## Case for changing the CCMA for the area east of the River Sid and Sidmouth East

The following is taken from East Devon Local Plan – Topic Paper – CCF- 005  
Adaptation and Resilience to Climate Change: Coastal Change **Yellow highlighted**  
for information relevant to East Beach.

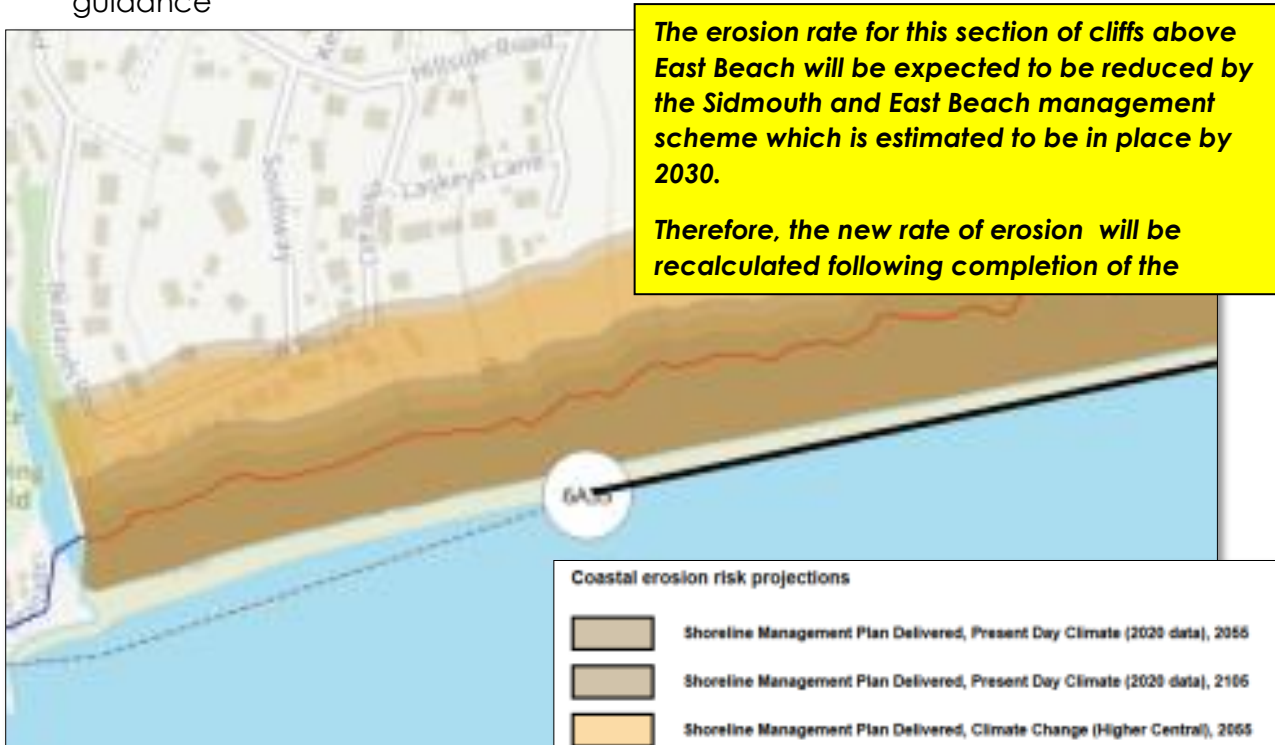
However, as the final design and specification for the BMP/BMS has not yet been designed or its effect determined it would be premature to quantify the erosion rate at this point.

Therefore because of new, as yet unknown factors that will only become apparent once the Sidmouth and East Beach project is finalised, the projected erosion rate is unable to be estimated accurately, and the estimation using the "worst case" scenario would be unjustified.

Map 34

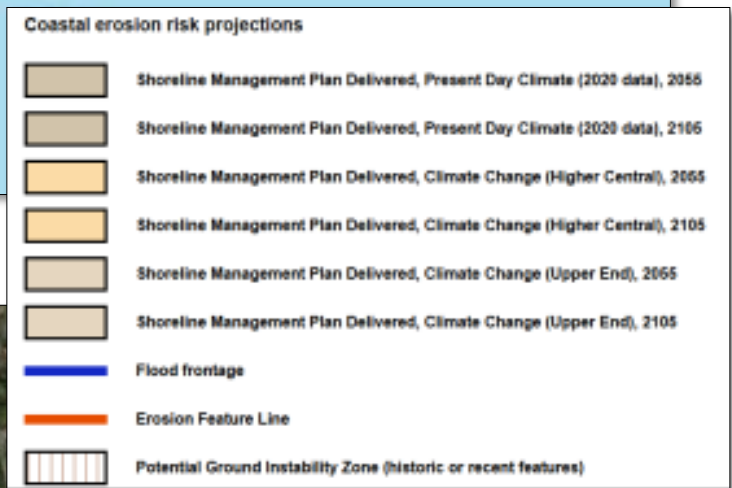
4.7 Most recently, the SMP's have been updated with maps that show the new National Coastal Erosion Risk Mapping (NCERM), which provides the most up to date national picture of coastal erosion risk for England. The relevant map 34 shows the coastal erosion risk projection climate change (upper end), 2105 to be very similar to that of the Sidmouth BMP OBC (see appendix A for plans from various sources that show differing erosion rates). This provides further evidence to justify the reduction in the size of the CCMA to the east of the River Sid in the Regulation 19 local plan.

The solution is to either not include any defined line or use the BMP OBC line but with a "health warning" that this is not yet conclusive line.

See maps on following page with yellow health warning

Therefore, some note of caution needs to be inserted to provide clarity and guidance
